**SUSQUEHANNA STEAM ELECTRIC STATION  
RESPONSE TO REQUEST FOR ADDITIONAL  
INFORMATION ON TECHNICAL SPECIFICATION  
CHANGES TO RCS PRESSURE AND  
TEMPERATURE (P/T) LIMITS  
PLA-7299**

**Docket No. 50-387  
and No. 50-388**

**Response to Requested Additional Information**

FIGURE 3.4.10-3  
Nuclear (Core Critical) Limit for ~~30.2~~ EFY  
(Curve C) **40**

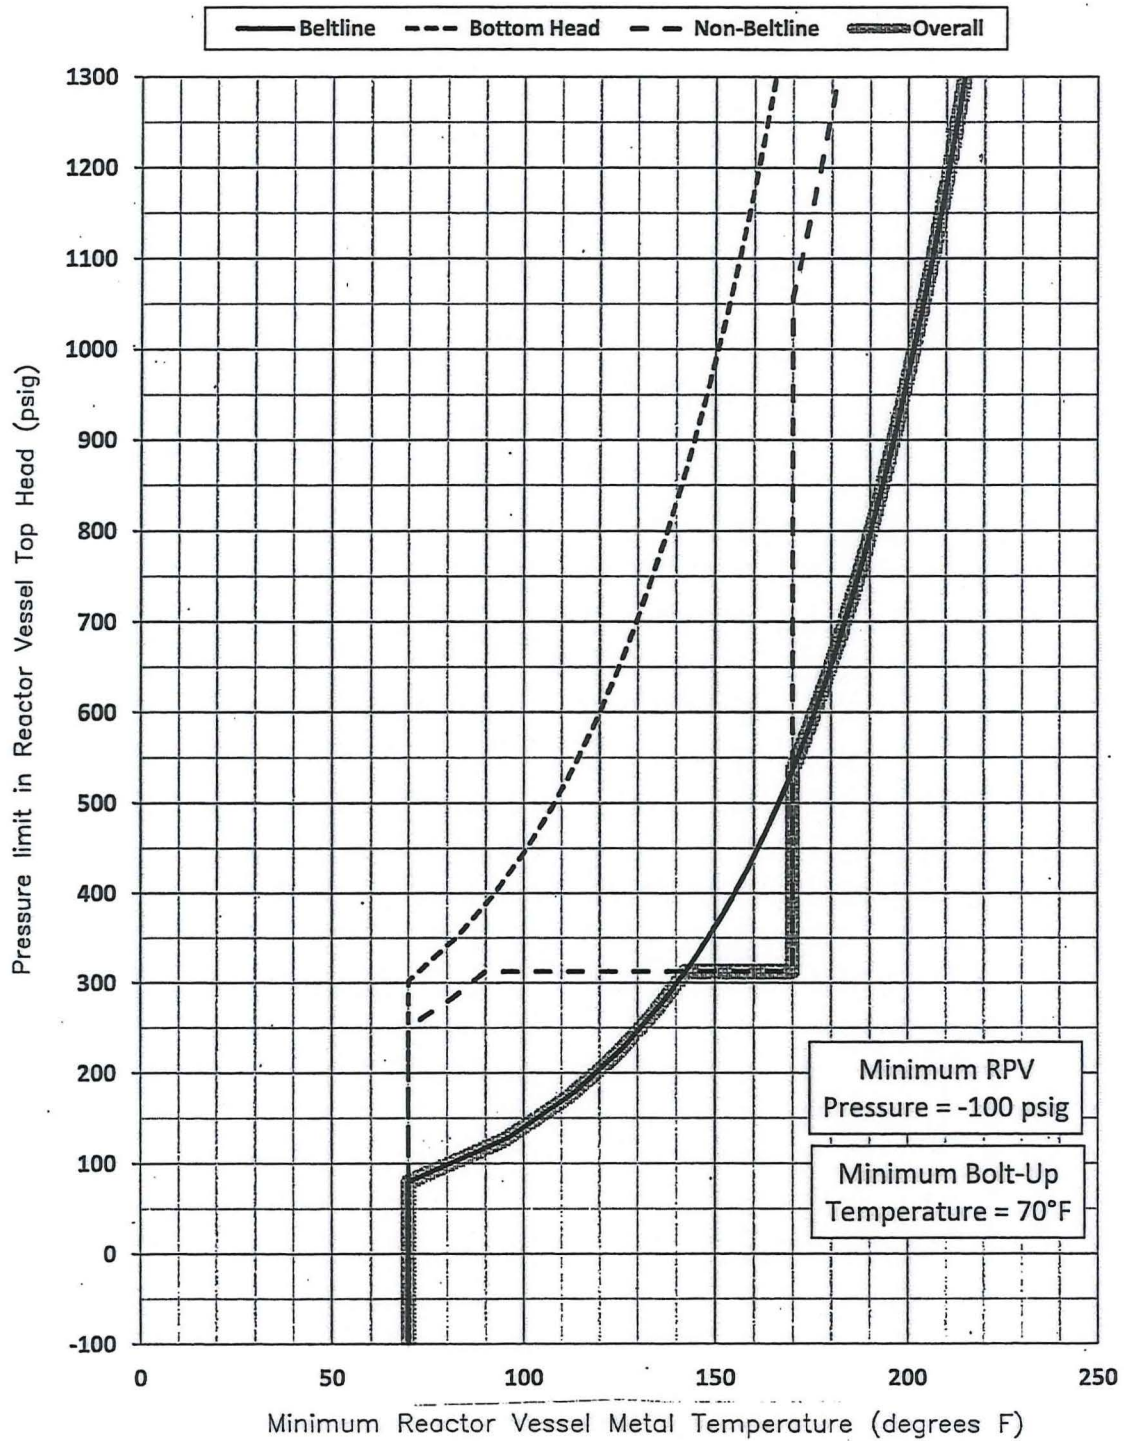
Whereas the licensee's proposed Technical Specifications (TS) change on TS Figures 3.4.10-1 through 3.4.10-3 shows P/T limit curves are extended to -100 psig. Any TS change should be consistent with the technical justification.

Please provide a justification for an extension of the P/T curves to -100 psig, or, TS Figures 3.4.10-1 through 3.4.10-3 should be revised to reflect the maximum vacuum of -15 psig as described in the submittal (i.e., adjusting the axis to end at -15 psig, terminating the P/T curves at -15 psig on the current scale, etc.).

The technical justification for allowing an extension of the P/T curves to -100 psig is provided in Attachment 3, which demonstrates that the P/T limits applicable at 0 psig are also applicable at negative pressures and that the RPV maintains structural margin at -100 psig.

The statement on Page 3 of 7 of the application (Reference 1), which states, in part, "The absolute maximum vacuum is assumed to be no greater than 15 psig," recognizes the fact that there is no possibility of drawing the RPV to greater than an absolute vacuum (approximately -14.7 psig). However, as detailed in Attachment 3, it is possible for the RPV to also experience an external pressure of approximately 2 psig due to drywell pressurization. In this case, the effective pressure on the RPV would be -16.7 psig (-14.7 psig - 2 psig). Thus, there is a possibility, albeit remote, for the RPV to experience an effective internal pressure of -16.7 psig, which does exceed an absolute vacuum.

It is also recognized that there is potential variance and uncertainty in the measured steam dome pressure under a vacuum, using the installed instrumentation. By extending the P/T curves to -100 psig, PPL's intention is to avoid future concerns should any vacuum reading ever exceed -15 psig. The extension to -100 psig is expected to cover any reasonably foreseeable variance in steam dome vacuum measurement.

A final point in response to this RAI is that the extension of the P/T curves to -100 psig matches the scale and format of the existing P/T curves (i.e., pressure values are in increments of 100 psig). Furthermore, extending the scale to -100 psig, even though the RPV will never experience such a vacuum, is analogous to the upper limit of 1300 psig on the P/T curves, which would also be unattainable, assuming the RPV safety relief valves operated per design. During startups/heatups, the operators would not pressurize the RPV significantly beyond 1000 psig.
